REGIONAL REVIEW NOTIFICATION

ARC REVIEW CODE: R1803211

Name of Proposal: Fiserv Property Redevelopment (DRI 2783)

DRI
SITE PLAN

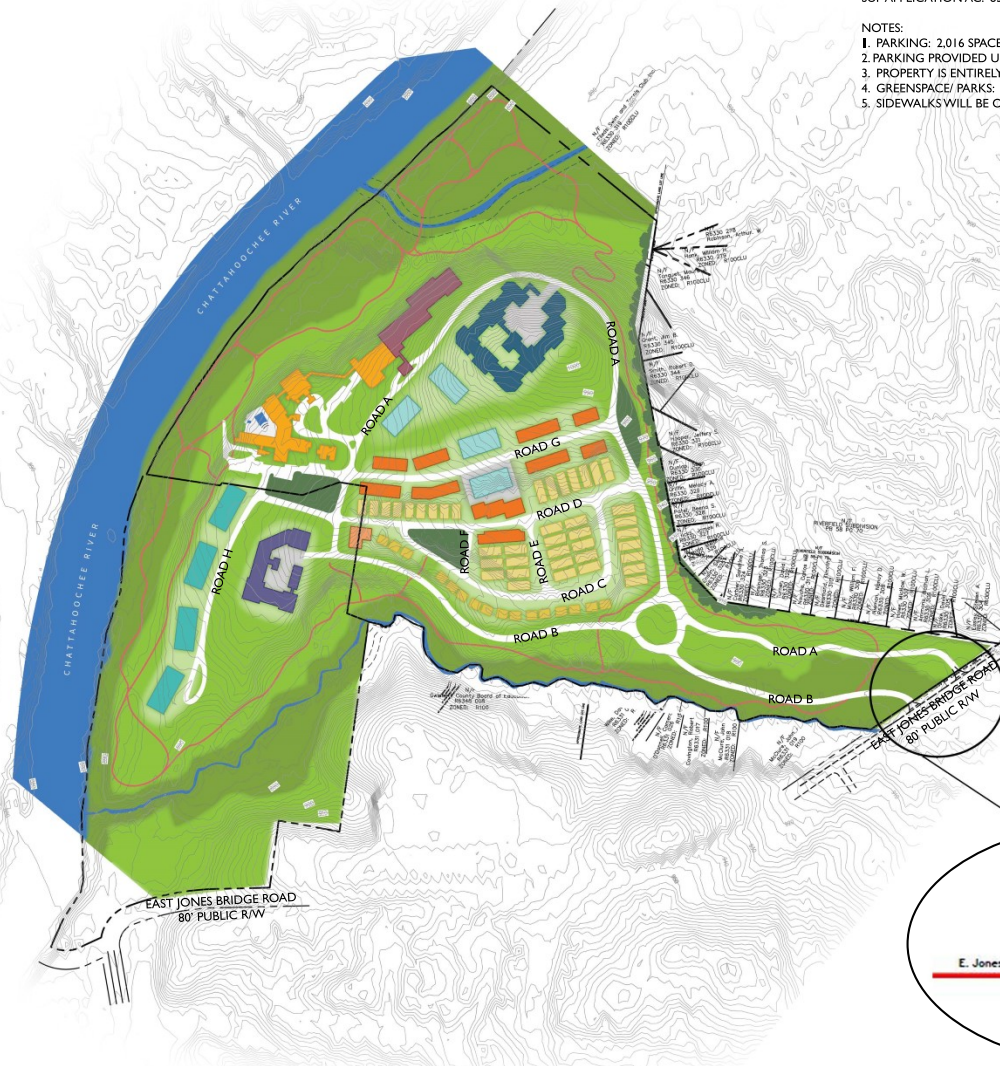
There are stub outs where local roads are planned to connect to the site however the site does in anticipate vehicular connectivity.

Adjacent parcels are undeveloped wooded areas. Existing roadways include pedestrian facilities, however internal driveways do not include connecting facilities. The site plan and traffic study do not indicate pedestrian facilities will be developed.

Information not provided.
